# **CBD Update and Proposed Business Expansion Area**

**Hebron, Connecticut**

## **Eastern Connecticut Environmental Review Team Report**

**June 2000**

Figure 3.

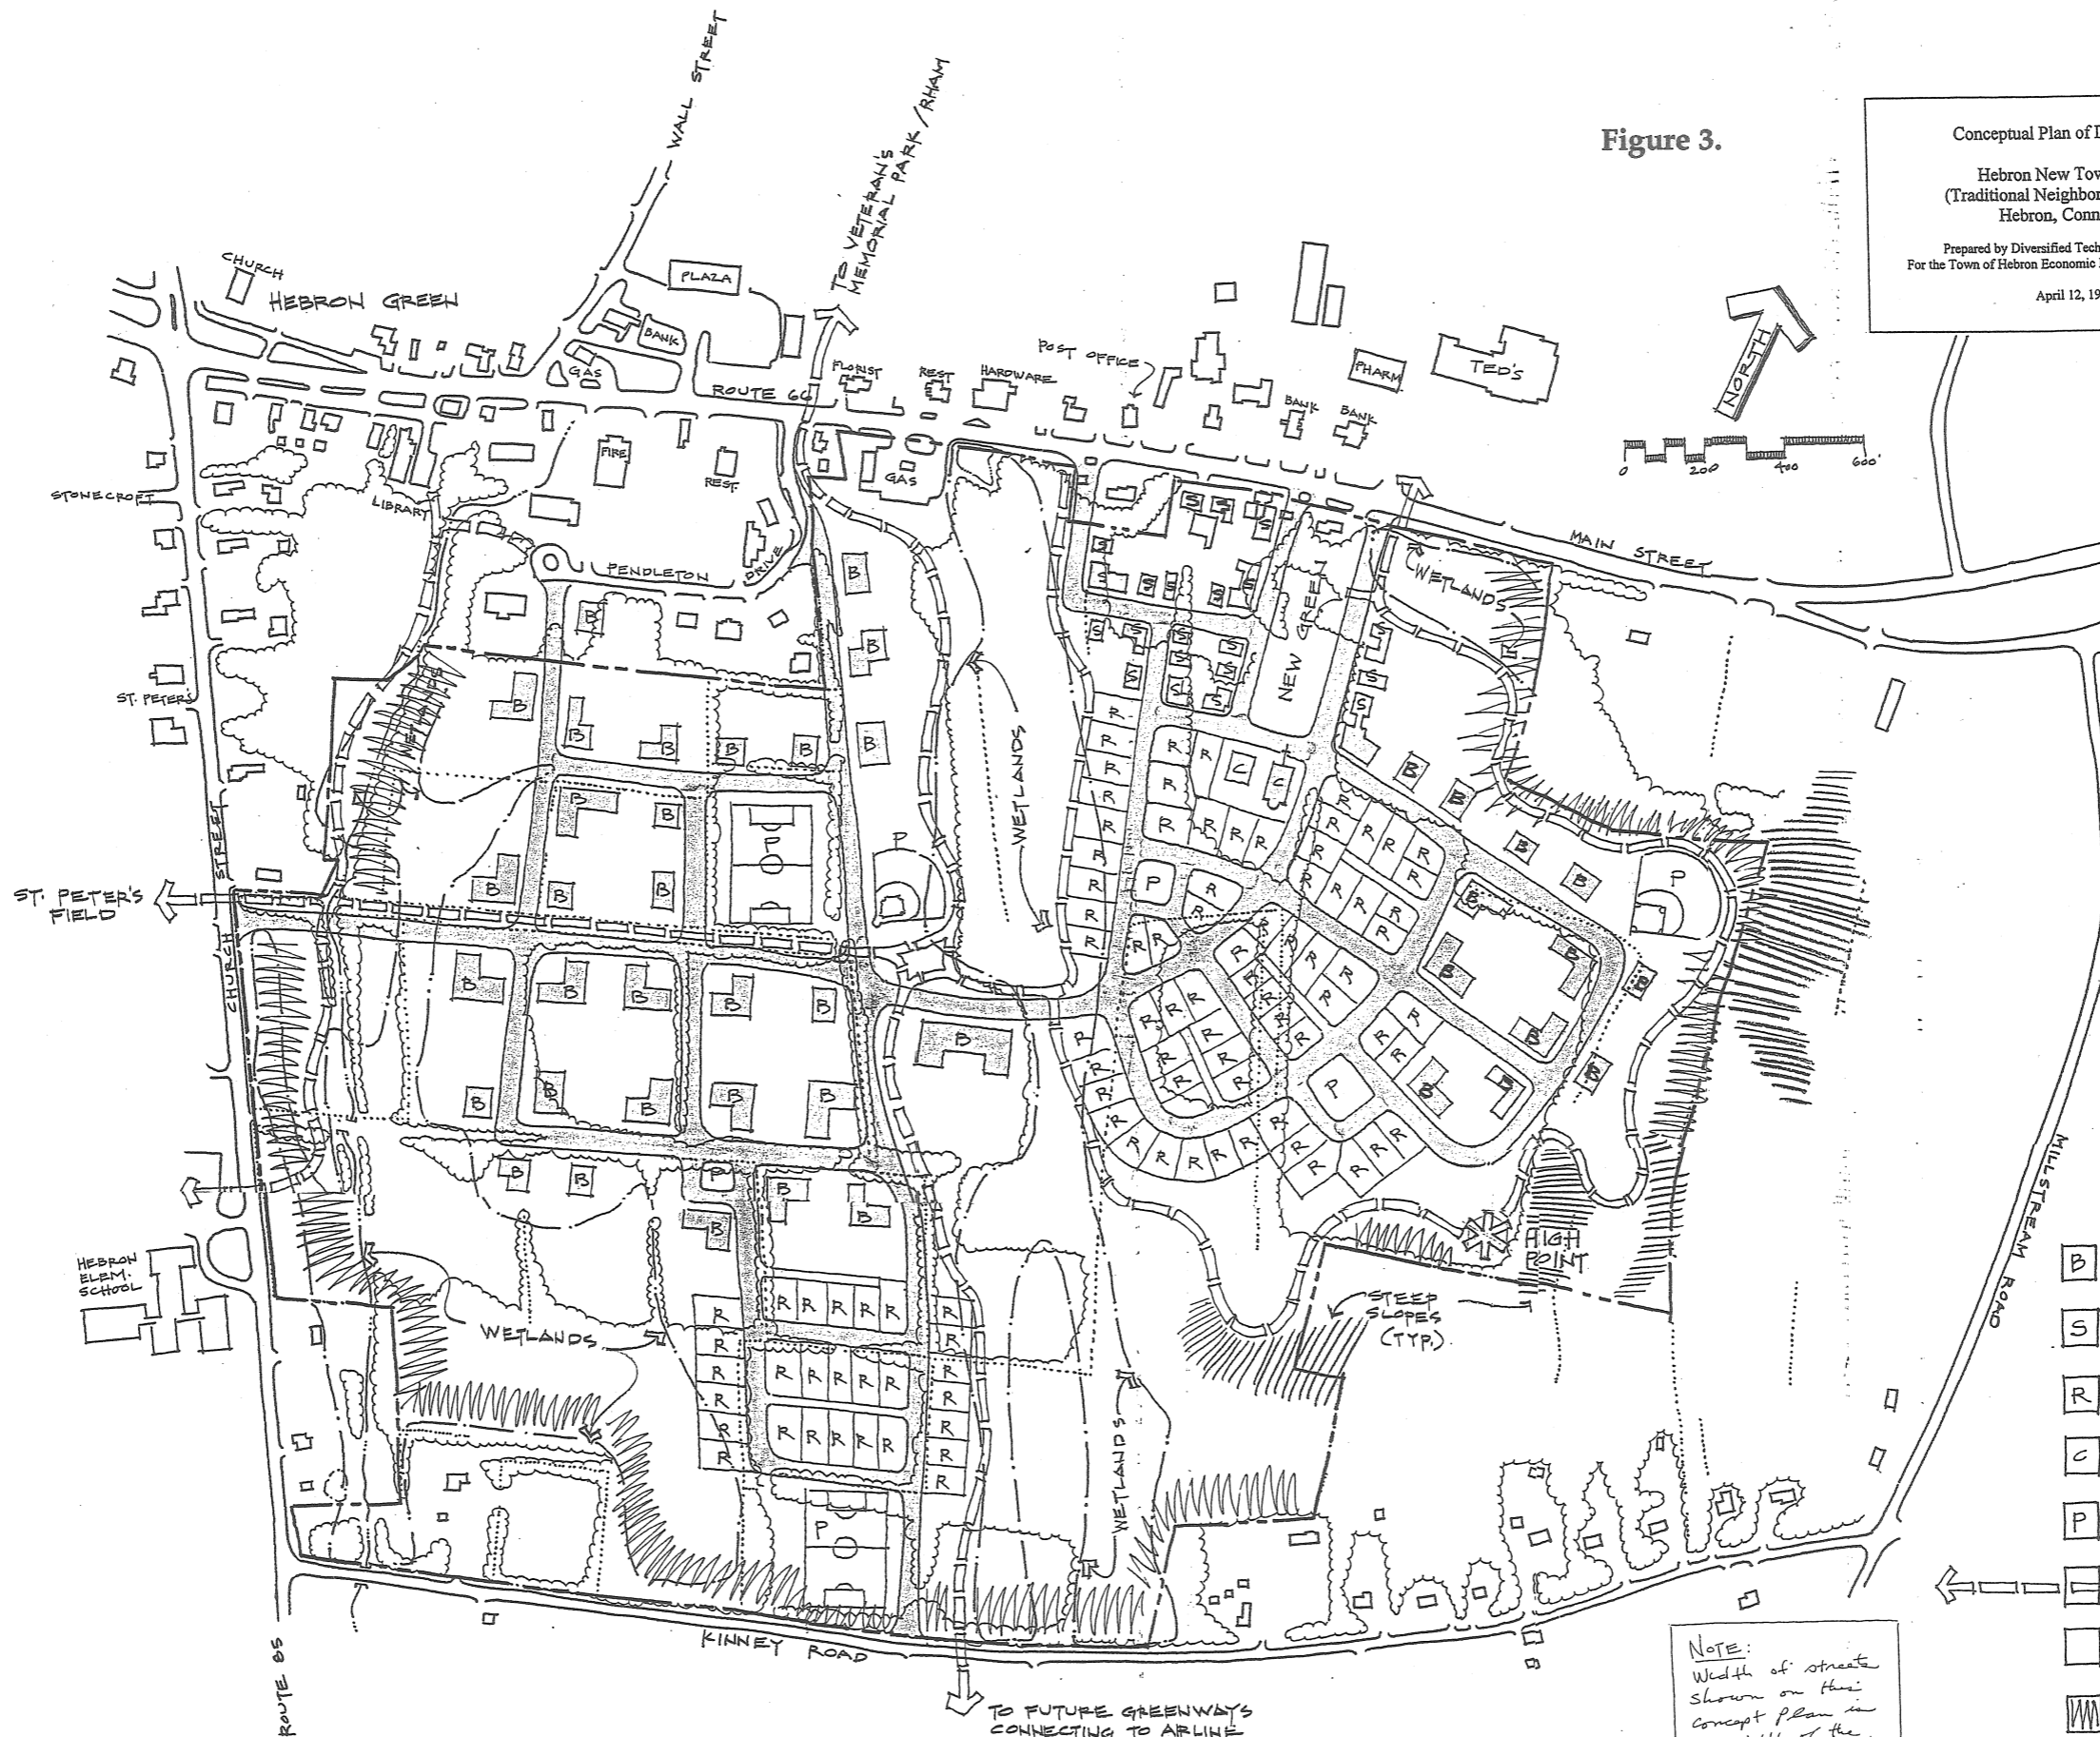
The current "Conceptual Plan for Development" shows a relatively dense mix of commercial and residential development with an interconnecting network of roads. The dense development is consistent with the "town center" concept. However, measures should be taken to reduce the impact of increasing impervious surfaces. These impacts are well documented and include increases in peak flows and degradation of water quality. The site is within the watersheds of Raymond Brook and the Jeremy River.

It is evident that the plan for the expanded business district not only proposes several areas of direct impacts (filling) to wetland areas as mapped on the conceptual plan, but also severely encroaches upon the upland buffers recommended above. The wetland areas indicated appear to have been transferred from the Town Wetland Map and therefore may significantly change,

perhaps increasing the amount of impact, once more detailed wetland mapping is conducted. It is strongly recommended that more attention be made to preserving existing wetland areas as well as maintaining an adequate amount of upland buffers to provide additional protection to these valuable resources. In addition, it is advised that areas of previously impacted wetlands be identified for wetland restoration opportunities.

The impact of development of the review site would be to remove additional land from open space and forest land from the potential production of forest products. Development of the site as depicted in the *Conceptual Plan of Development* by Diversified Technology Consultants, April 12, 1999 would preclude long term forest management. Tree removal and vegetation clearing would take place on a significant portion of the site. Therefore, careful selection of the trees to be retained as well as their protection during construction will be necessary.

The Team planner conducted a general soils analysis based on the Soil Map Table from the 1984 ERT report. Based on this analysis, she believes that the structures on the Master Plan are sited appropriately. However, a significant amount of the site is defined as "severe" for structures and roads. If the site is developed as indicated, roads will need to be extended through areas with "severe" limitations, which will necessitate additional engineering expenditures. In addition, these limitations mean that water and sewer lines across the site may also be more expensive to construct. The flood control, water quality, and habitat functions of the existing wetlands will be compromised to some degree.

- One issue is whether business structures, which will be largely unused during evenings and weekends, should be mixed with the other uses, or segregated from them as shown on the existing Master Plan. There are advantages and disadvantages to each approach. If the business district is segregated, a large part of the development will be vacant and quiet weekends and evenings. If the business uses are mixed with other uses, there will be more activity dispersed across the site and more of the site could be utilized, although pedestrian activity may be less concentrated.

- At present, the site design does not seem to include a “main street” through the Master Planned area. It may be beneficial to identify a main street with appropriate streetscape design, so that key retail and commercial tenants feel they are getting good visibility.
- Consider designating parking on one side of streets.
- Consider implementing one-way roads where feasible, for two reasons:
  - 1) Will result in reduced impervious surface; and

- The modified grid design of the Master Plan is effective. The goal should be to preserve existing topography, but also to develop a compact street layout.
- The majority of parking should be located to the periphery of structures and greens where possible, particularly in the business district.

- The Master Plan has a good series of pedestrian connections with surrounding civic and commercial uses.
- It would be advantageous to develop a well marked, passive recreation trail (may be low impact, gravel) that is accessible to area residents. The goal should be to connect with area residences in a low-impact manner.
- A significant investment in sidewalks will be required. Also, one to two pedestrian signals across Route 66 will be required.
- If additional active recreational facilities were developed on-site, for example a green where a public event such as a small fair or arts and crafts fair could be held, additional activity on weekends would be ensured.

Figure 4.

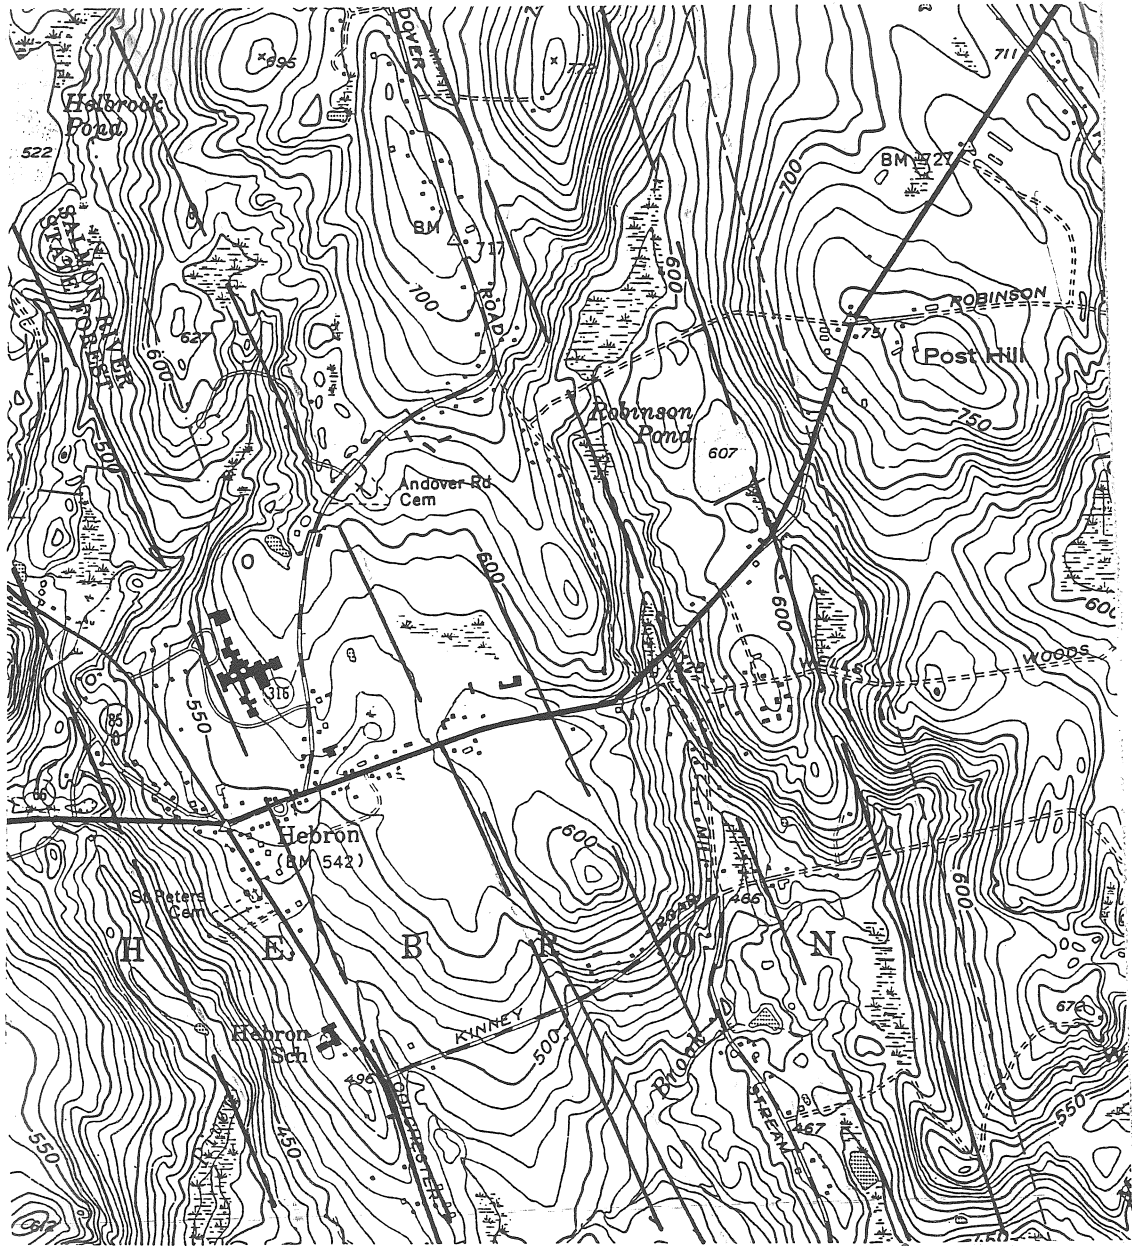
Most domestic water wells in this area are recharged by bedrock aquifers. Metamorphic rock has practically no porosity to hold groundwater except for fractures. Water is only able to enter well-bores through the fractures that the well intersects. The more fractures, generally the better supply of water. Because fracture orientation is one control of topography, analyzing a topographic grain provides clues to potential areas with more closely spaced (denser) fractures and hence to areas with better groundwater resources. Several NNW-SSE topographic lineaments, where increased fracture density may be encountered, pass through Hebron with a semi-regular spacing of about 3/8<sup>th</sup> mile. Two pass through the proposed CBD expansion area (see Figure 4).
